MG Knit Flair Ltd. (9200)

MG Shirtex Ltd. (9594)

05.APRIL.2014

Identified Priority 1 Concerns

High Column Stress

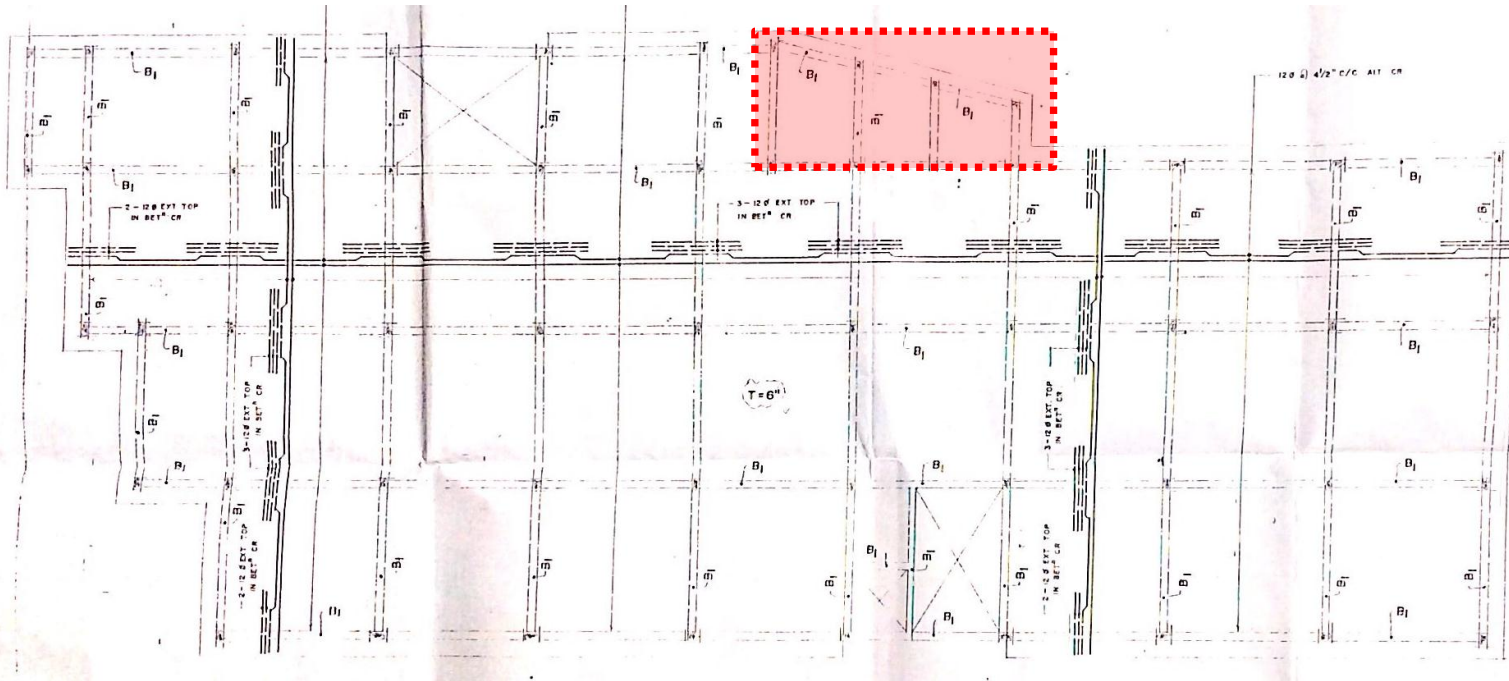
Low Column Safety Factors

Priority 1 Concern

Although, storage levels were very low. Under minimum allowable live loading, column load run-downs yield lower than desirable safety factors.
